MEMORANDUM

To: Craig M. Failor – Oak Park Village Planner
From: Floyd D. Anderson, AIA & Rich Van Zeyl, AIA
Date: 7/6/2017
Subject: 1000 Lake Street

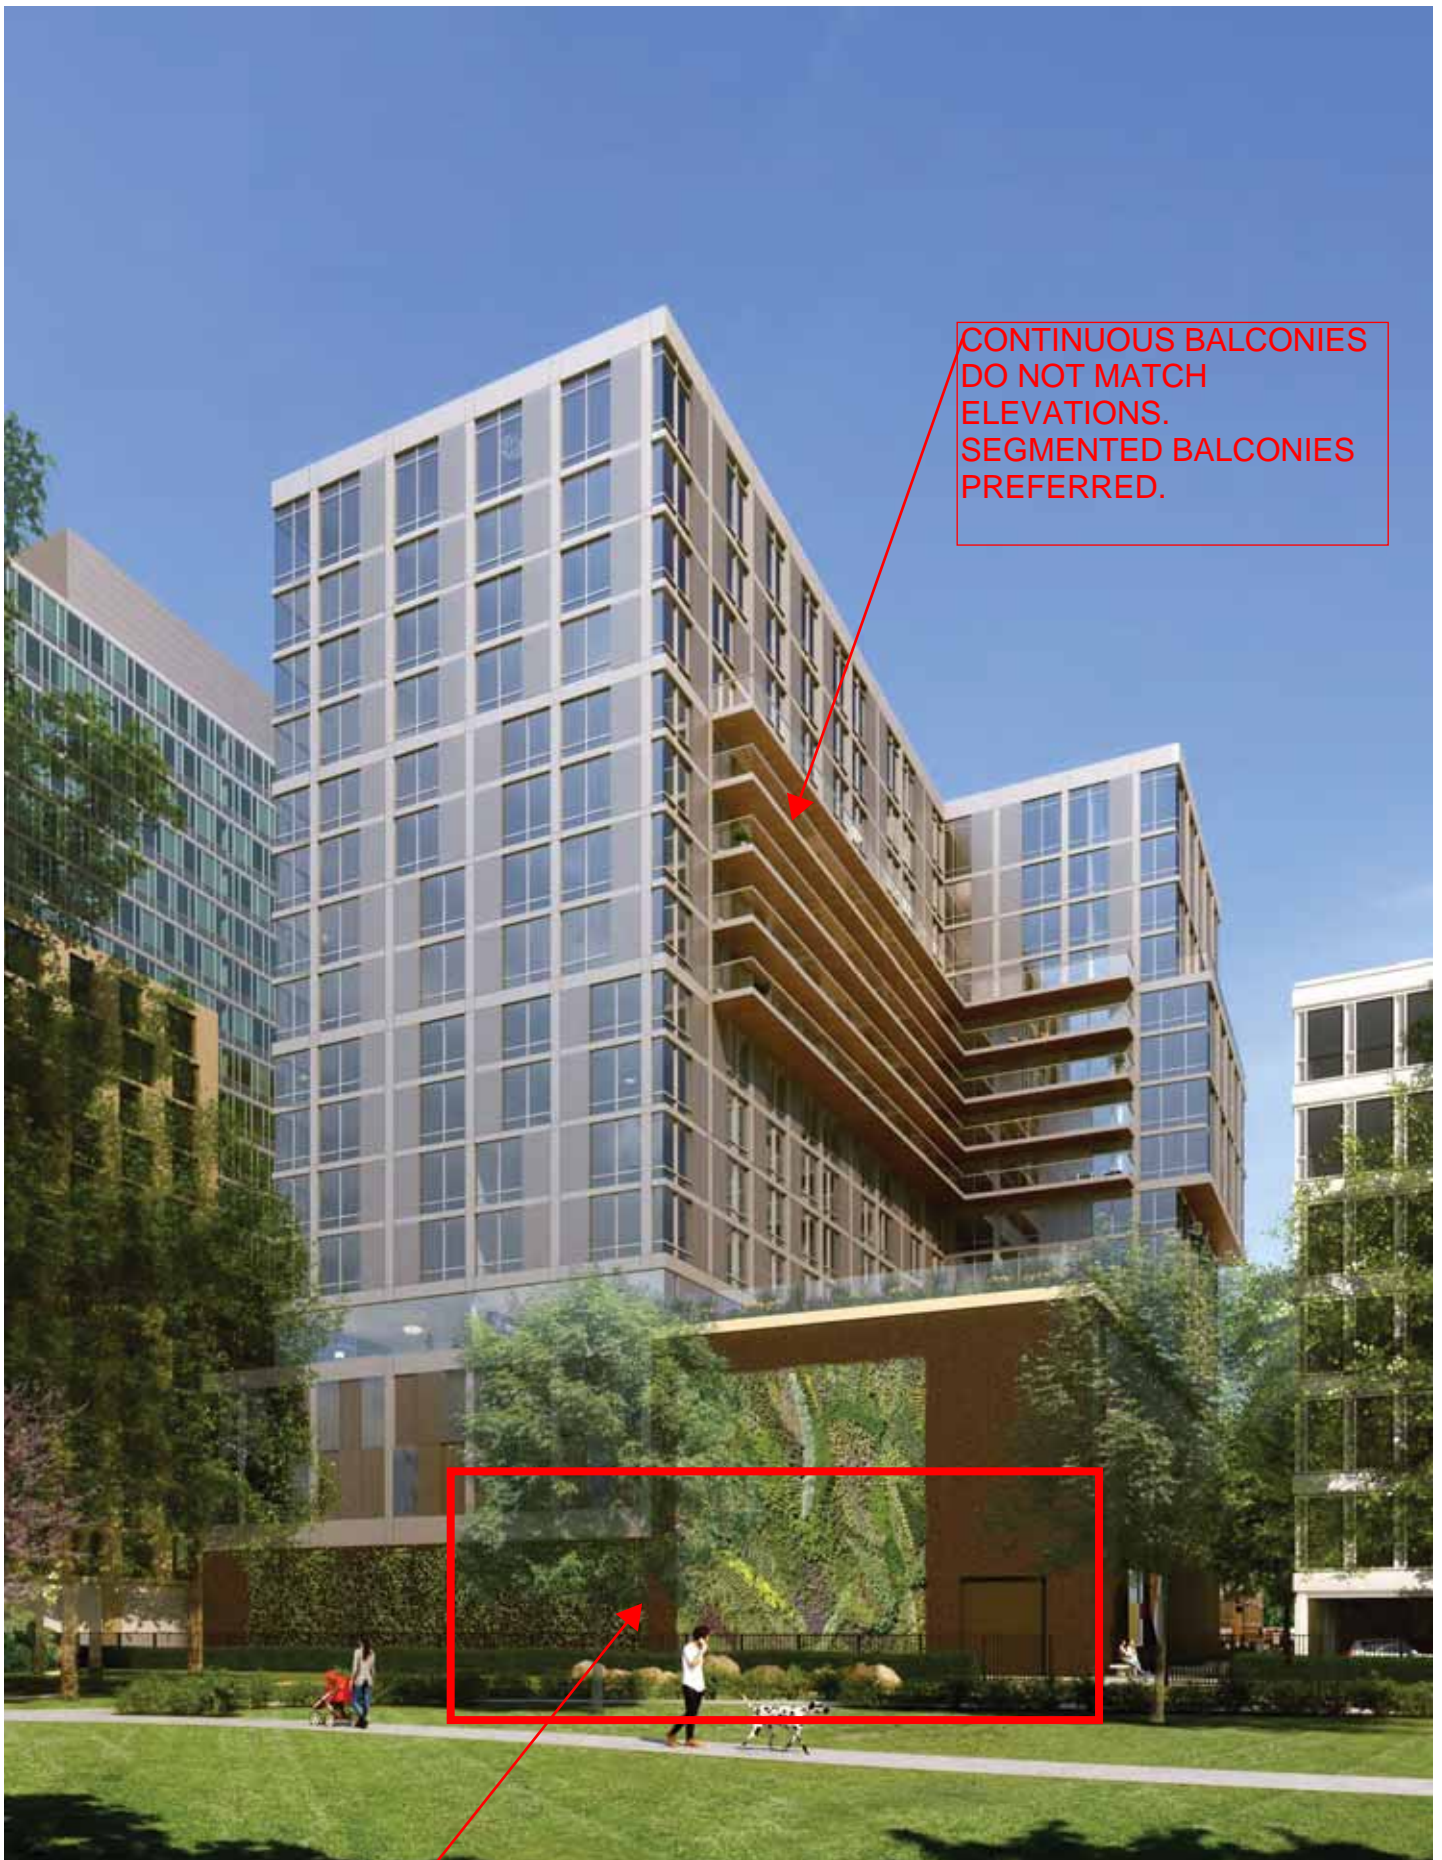
Item #1 – The balconies on the center floors of the building, as viewed from Austin Gardens, are not shown consistently between the elevations and renderings. The elevations show segmented, individual balconies, where the rendering shows a continuous balcony that turns around the building at the inside corner. In speaking with the architect, he noted that the rendering showing the continuous balconies is correct and the building elevations will need to be corrected. We strongly feel the segmented balconies as depicted on the elevations are more successful, and the continuous balconies in the renderings

should be modified. It would also be helpful to see the new Austin Gardens Environmental Education Center in the context of this rendering.

CONTINUOUS BALCONIES
DO NOT MATCH
ELEVATIONS.
SEGMENTED BALCONIES
PREFERRED.

SHOW EDUCATION
CENTER IN CONTEXT

West Elevation - Connection Walk Way

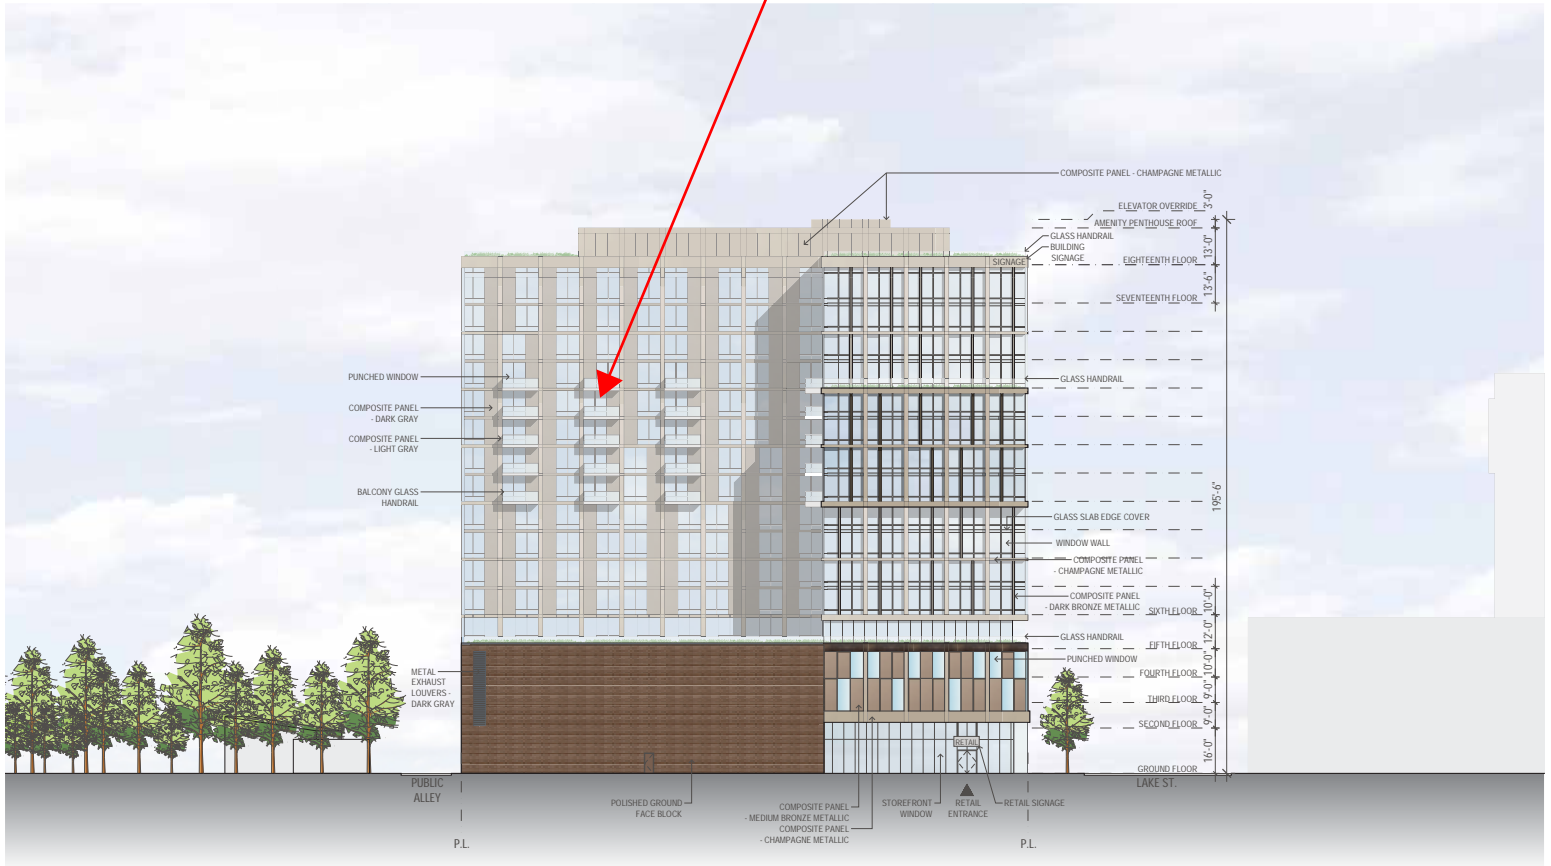
SEGMENTED BALCONIES
DO NOT MATCH
RENDERING.

GROUND LEVEL LANDSCAPE PLAN

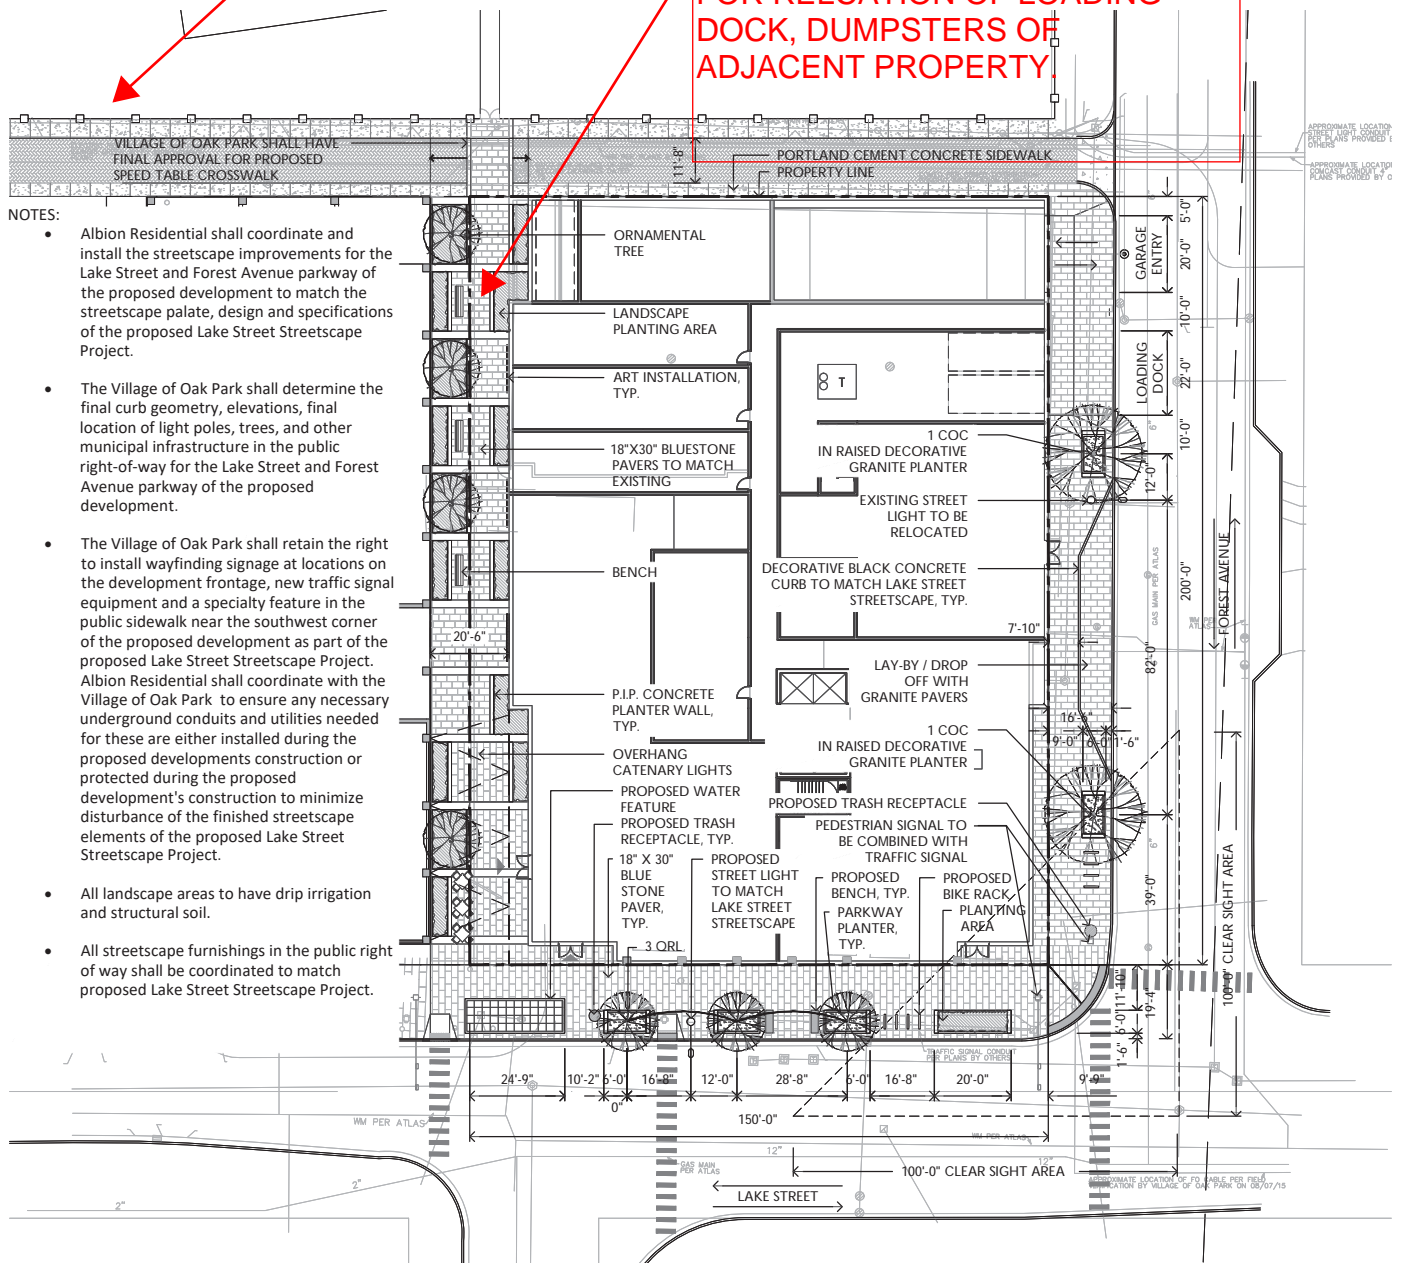
Item #2 – We are very supportive of the development of the open space on the west side of the building at ground floor that is shared with the neighboring property. This will be a great public amenity and will work very well with the proposed restaurant in the southwest corner of the project. However, we have concerns about the functionality of this space. The landscape plan depicts this as a continuously paved and landscaped area, from Lake Street to the gate that enters Austin Garden. Currently there is a loading dock and trash dumpsters for the neighboring property at this location. In speaking with the architect, he noted that these functions are being relocated either into the new building or a new location within the adjacent building. We would like to see a plan and agreement that illustrates and confirms this arrangement. Also, the location of the gate on the site plan does not appear to align with the actual conditions. The water cistern of the new building in the park is on axis with the proposed public space, and the entrance to the park is further to the west. The architect should revise the site plan to reflect the actual conditions.

PROVIDE PLAN AND AGREEMENT FOR RELOCATION OF LOADING DOCK, DUMPSTERS OF ADJACENT PROPERTY.
